**BMP NUMBER: CC026**

PROPOSED STORMWATER MANAGEMENT,  
EROSION, AND SEDIMENT CONTROL  
FACILITY 'A'.

SWM FACILITY 'A'  
ROUTE 5  
GRADING PLAN

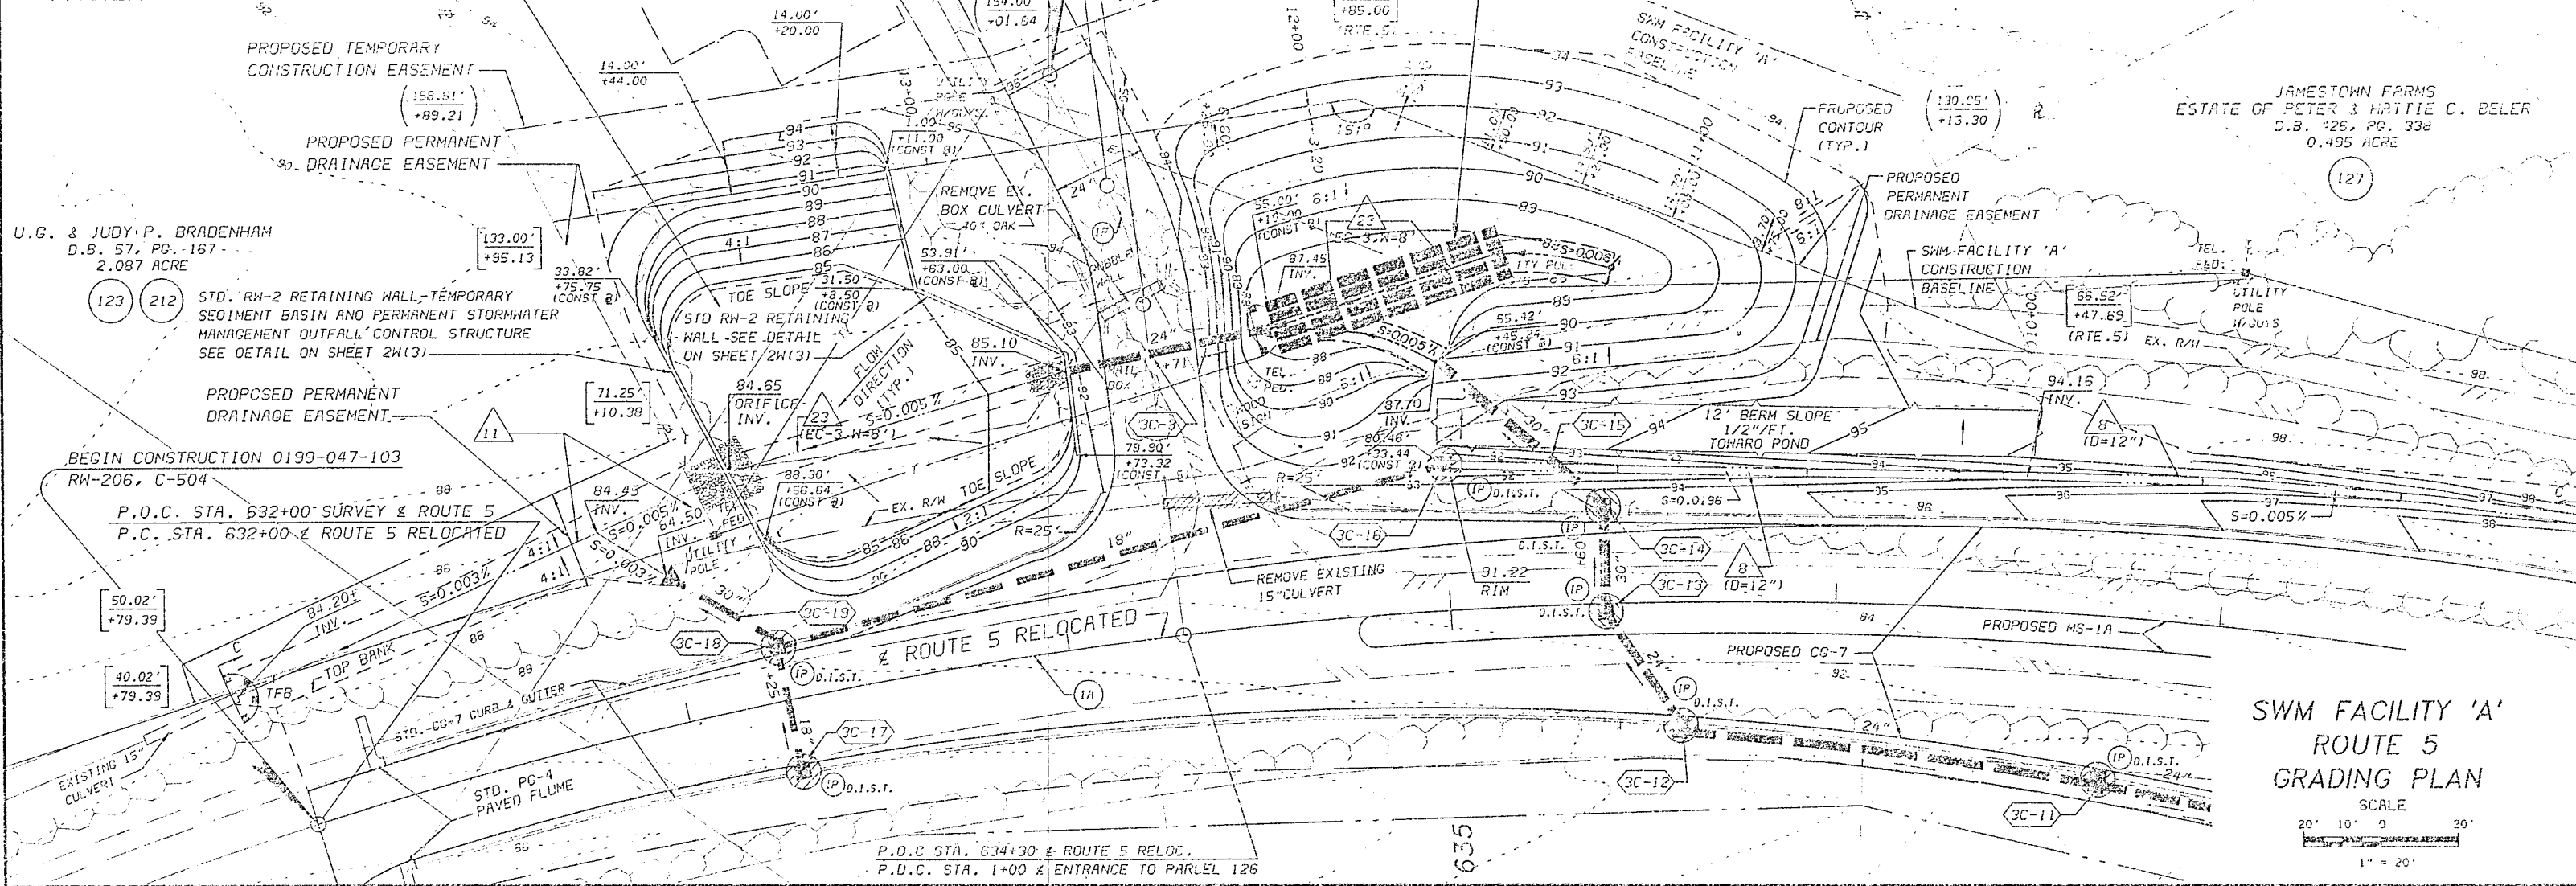
- Q: Can normal pool be adjusted? 3/23/98
1. EXISTING POOL LEVEL TO REMAIN IF POSSIBLE.
  2. REMOVE PORTION OF BERM IN CENTER OF PROPOSED WET BASIN (OR ALL OF BERM).
  3. CREATE WET BASIN 4' DEEP INSIDE DASHED LINES.
  4. WHAT TYPE OF SOILS ARE IN THE BOTTOM OF BASIN? THEY NEED TO HOLD WATER
